TECH TIP

Group:	0-GENERAL
Bulletin No:	TT-16-009
Issue Date:	9-14-2016
Reference:	HMM-160913-J1

DEF INJECTOR ASSEMBLY REPLACEMENT

SUBJECT VEHICLES: 11MY-17MY Conventional Trucks or 13MY-17MY COE (Cab over Engine) Trucks

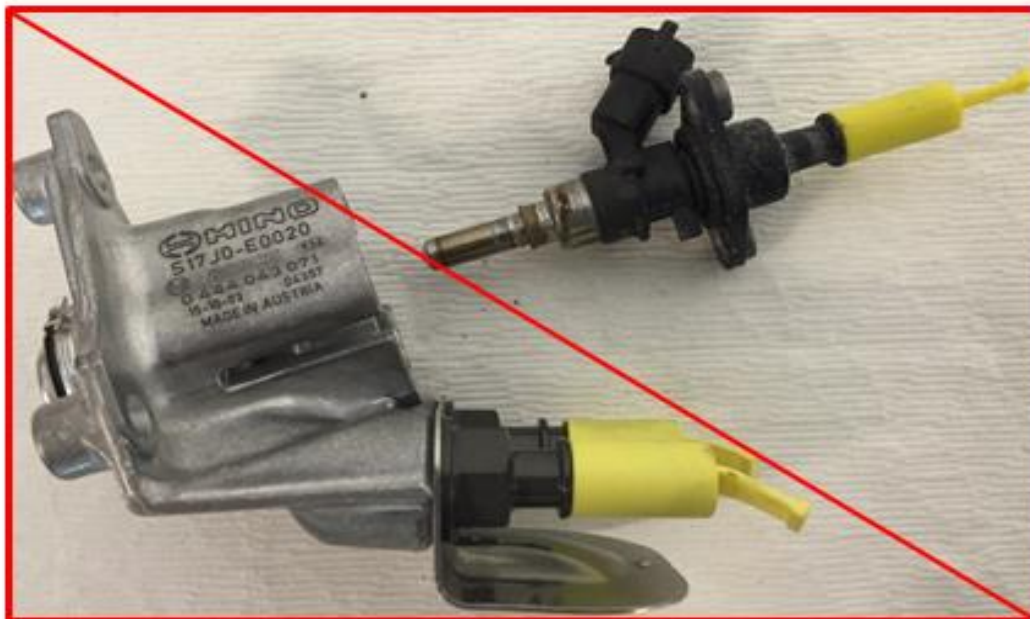
Current production DEF injectors contain enhancements including improvements to the aluminum housing. When replacing the DEF injector, it is necessary to install the complete DEF injector assembly (Part no. S17J0-E0020) onto the vehicle, not only the center injector portion. Replacing only the center portion of the DEF injector and reusing the existing housing WILL result in warranty charge back.

Do Not Separate Injector from Housing
